March 26, 2013

RE: Proposal to Ship Hanford High-Level Radioactive Waste to New Mexico

We write to you regarding the Department of Energy's (DOE) News Release and subsequent publication in the Federal Register on March 11, 2013 of DOE's "preferred alternative" to retrieve, treat, package, characterize and certify certain Hanford tank wastes for disposal at the Waste Isolation Pilot Plant (WIPP) in Carlsbad, New Mexico.¹ As detailed below, DOE's proposed course of action would fail to resolve or meaningfully address potential threats to the Columbia River from leaking high-level radioactive waste (HLW) tanks at Hanford. The waste proposed for treatment and transfer to WIPP is too small a fraction of the total inventory of Hanford tank waste to make the investment worthwhile and the proposal does not prioritize the leaking single-shell tanks. Further, DOE's "preferred alternative" would likely have a disastrous impact on both efforts to arrive at a national nuclear waste strategy and associated progress at the WIPP facility from legal, technical and institutional perspectives.

WIPP Bound Remote Handled Transuranic Waste
(including the content of 9 HLW Tanks at Hanford)

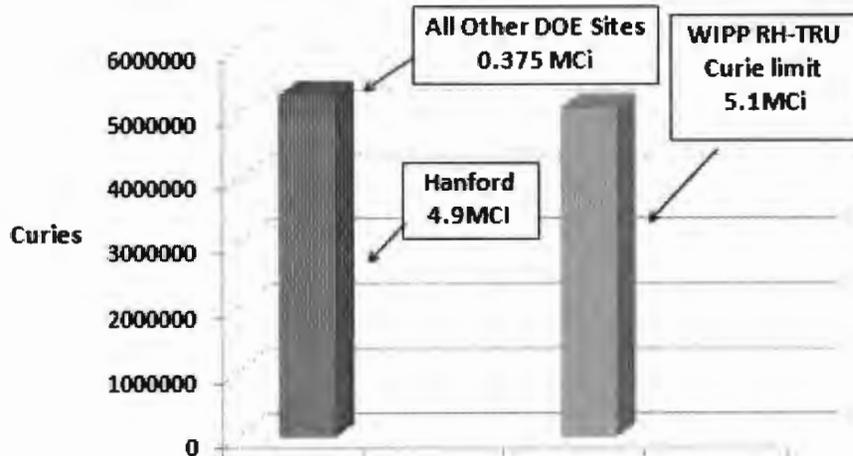
Along with ensuring you are clear on the status of HLW law, we would like you to consider the characteristics of the wastes in the 20 Hanford tanks named as candidates for disposal at WIPP. An analysis of Hanford's TWINS database reveals that the radioactivity content of these 20 Hanford tanks named in the EIS come close to almost entirely filling the radioactivity limits for the WIPP facility. Specifically, for remote-handled Transuranic Waste (RH-TRU), the curie content in the Hanford tanks is 4.9 million curies. WIPP's RH-TRU limit for such waste is 5.1 million curies.¹¹

Apparently, DOE has no plans to remove radionuclides from these wastes, and instead relies on a plan to simply remove and dry the tank waste according to Appendix E of the Final TC & WM EIS. However, in order to stay under the curie limit for WIPP, either the current law will have to change to substantially increase the curie limits for the RH-TRU, or DOE will have to decontaminate the sludge (10-20% of the volume containing ~95% of the Sr) and the Cs in the salts (80-80% of the volume containing ~90% of the Cs.). This will likely involve the use of sludge washing. Once these contaminants are removed, we have no information where DOE intends to dispose of these toxic radionuclides.
